FARR WEST CITY PLANNING COMMISSION AGENDA

RE: **DOMINION ENERGY 1200 WEST REGULATING STATION
Site Plan Review**

Our office has completed a review of the site plan for the Dominion Energy Regulator Station located at 1301 North 1200 West. This new regulating station will replace the existing station further north on 1200 West. We recommend approval of this plan subject to the following comments:

LINE NUMBER: FACILITY: TITLE: DESCRIPTION: ADDRESS:			FL - 19 INSTALL NEW DR STATION GD0042 (RETIRE DR STATION GD0038) SITE PLAN 1301 NORTH 1200 WEST		
CITY FARR WEST	COUNTY WEBER	STATE UTAH	DRAWING NUMBER DEU-R-GD0042-CCS-001	SHEET 04 OF 09	REVISION A

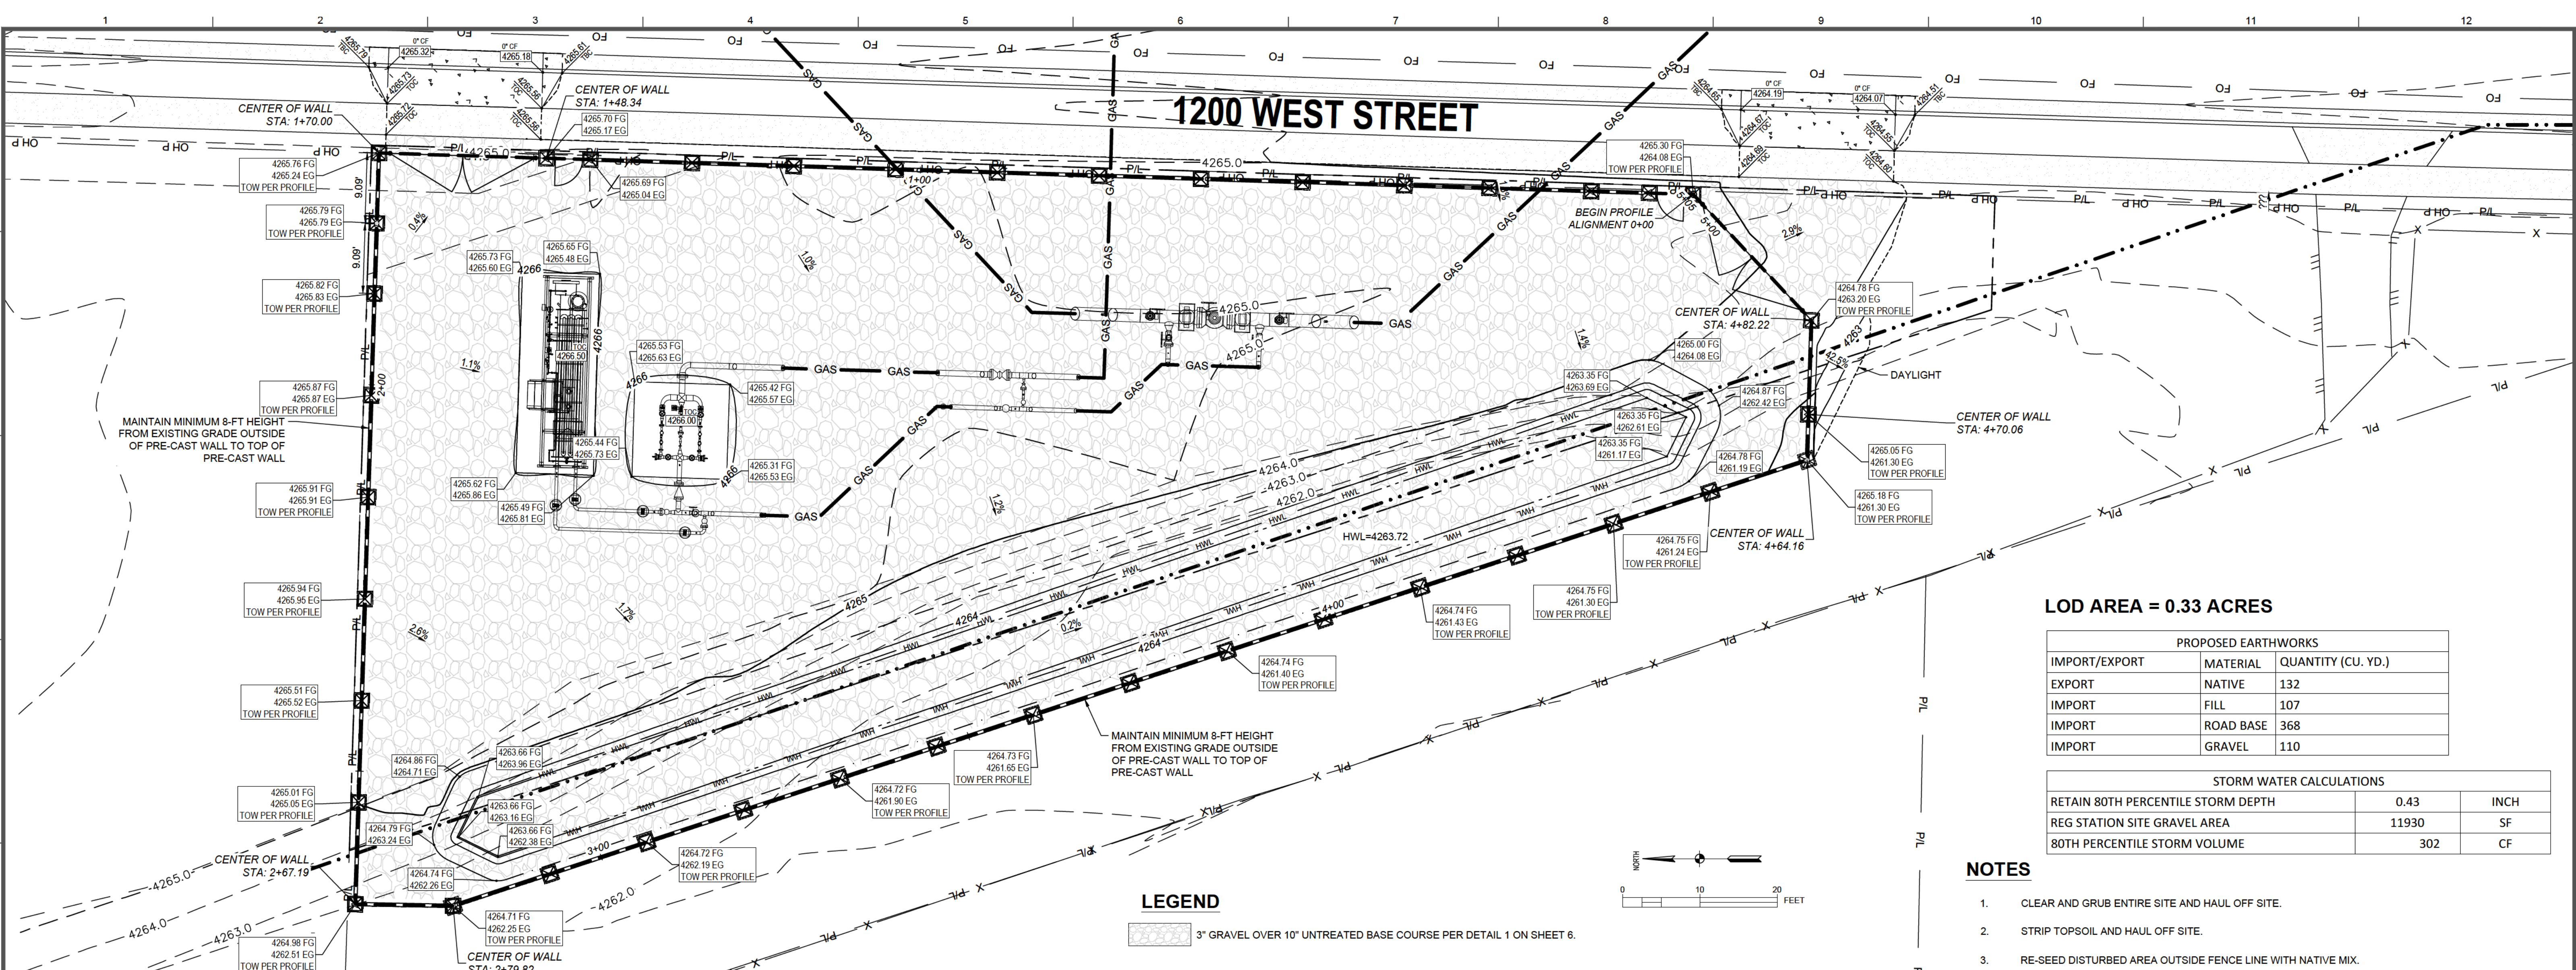
1. There is a 24" irrigation drain line which crosses the west end of this property that is not shown on the plans. Clearly identify this pipe and ensure that it does not interfere with the proposed gas improvements or a proposed fence post.
2. If one does not already exist, an access easement for the existing access to the back of the lot located at 1218 W. 1200 N. in the Mountain View Subdivision should be recorded with the County.
3. Provide storm water retention pond calculations for the runoff created from the site.
4. Increase the area shown for the stabilized construction entrance shown on the Storm Water Pollution Prevention Plan (SWPPP).
5. We recommend that the landscaping of the parkstrip with decorative rock extend through the entire frontage of the property owned by Dominion Energy.
